SERVICE BULLETIN – RECOMMENDED SB 014

Model:	M24C				
A/C Reg:	G-CGPB	G-CGYH	G-CGRY	G-CGRZ	G-CGVF
	G-YROR	G-YRAX	G-PLOP	G-CGTK	G-ORDW
A/C SN:	24105964	24116644	24106134	24106004	24116284
	24106034	24116194	24116204	24116214	24116274

<p>SB TITLE – DOOR WARNING SYSTEM</p> <p>REASON (for Mod/Action/Inspection) In order to improve the status of the door locking on the M24C gyroplanes Magni have introduced a new warning system. The system has a dual method of indicating to the pilot if a door has been incorrectly closed and locked. A new red warning light has been introduced onto the right hand end of the existing warning light cluster. The light bezel is marked 'DOOR' to clarify the significance of illumination to the pilot. In addition the warning system inactivates the rotor tachometer until the doors have been correctly latched and locked. This system therefore denies the pilot a primary instrument used prior to take-off roll, and hence aims to ensure that all doors are correctly latched and locked prior to the gyroplane becoming airborne.</p> <p>COMPLIANCE (Include Date of Effectivity and Timescales for embodiment) This service bulletin is effective from 28/10/2011. The service b

Attachment of Aft Door Pin Detection Switch

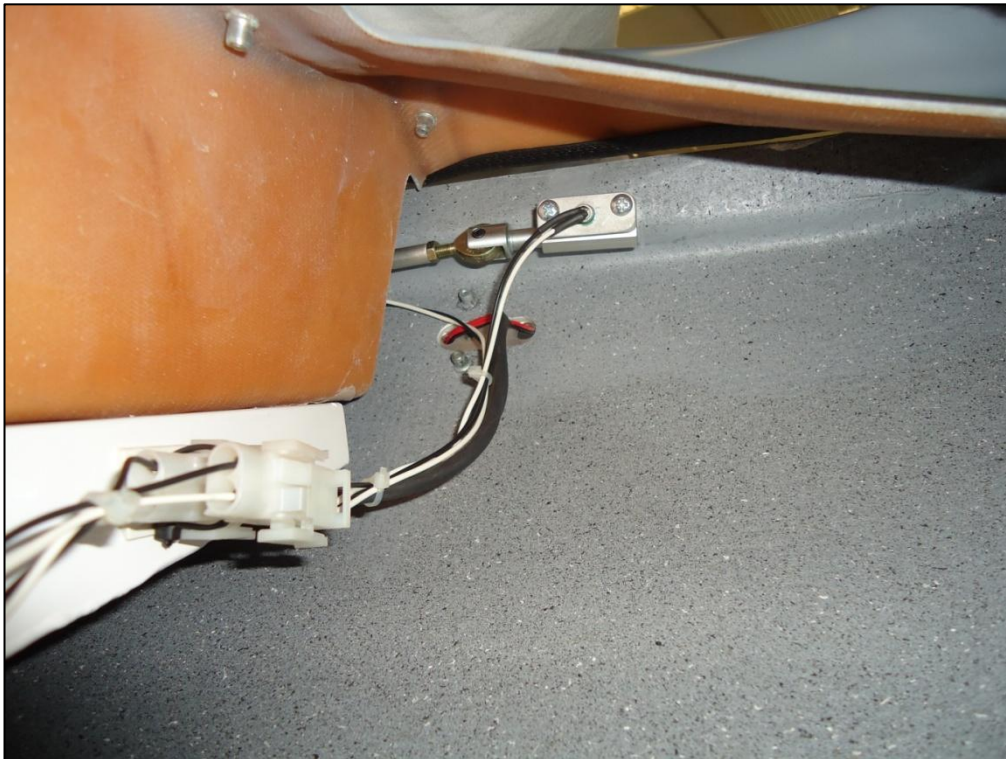
- 1) Remove seat from aircraft to gain access to aft door latching blocks.
- 2) Apply Loctite 222 to thread of switch and screw switch into support bracket (720-08-24) until switch shoulder face is flush against block face.
- 3) Screw support bracket to face of the existing latch block using supplied M4 x 12 screws. (Loctite should be used on the two screws prior to tightening)
- 4) Repeat steps 2 & 3 for second aft latch block.
- 5) Connect indicated wiring loom connections to aft switches and run loom laterally along the aft seat support members. Use tie-wrap bases to secure new loom to the lateral seat support members.
- 6) Run new loom forward along existing loom routing. Tie-wrap new loom to existing wiring loom every 6 inches and ensure wiring remains clear of control movements.

Attachment of Locking Handle Detection Switch

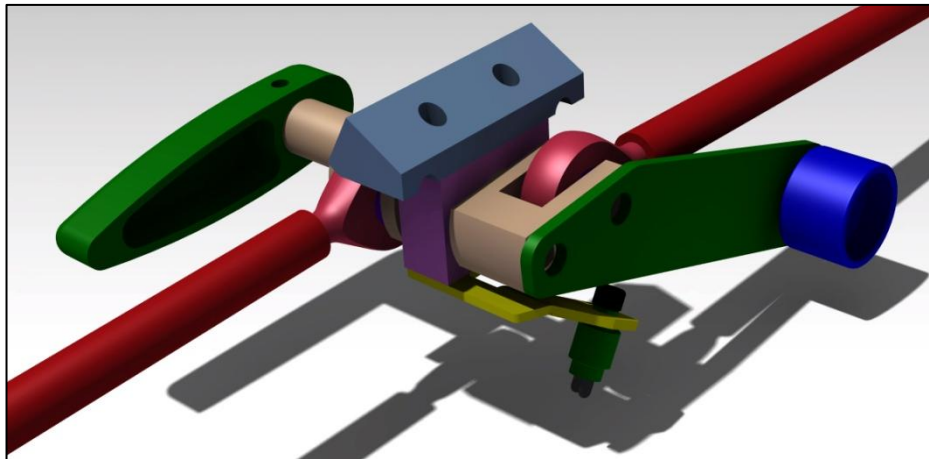
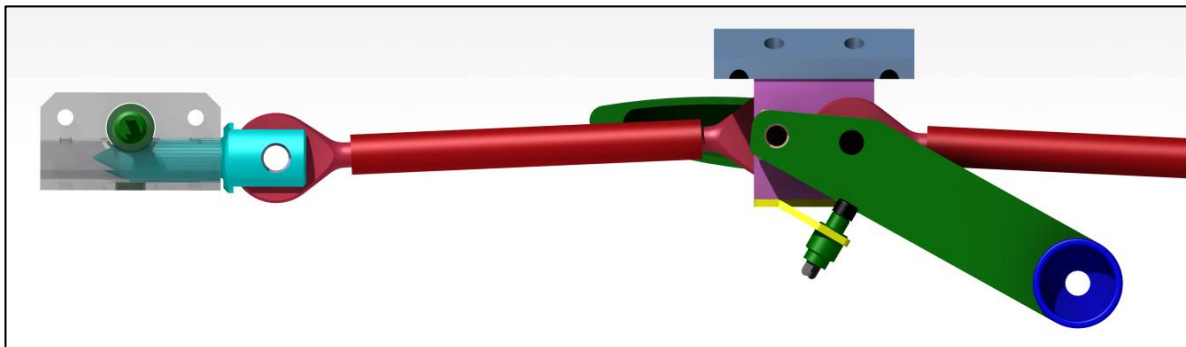
- 1) Secure switch to lever bracket (722-08-24) using manufacturer supplied collar nut. Use Loctite 222 to secure nut against movement.
- 2) Remove screws attaching the two PVC support blocks to permit same screws to attach lever bracket to bottom face of the lower PVC block.

- 3) Repeat steps 1 & 2 above for second handle detection switch.
- 4) Connect wiring leads from previously routed loom. Secure wires to fuselage using tie-wrap bases. Ensure all cables are secured away from control mechanisms.
- 5) Confirm switch is fully depressed when handle is placed in over-centre 'locked' position.
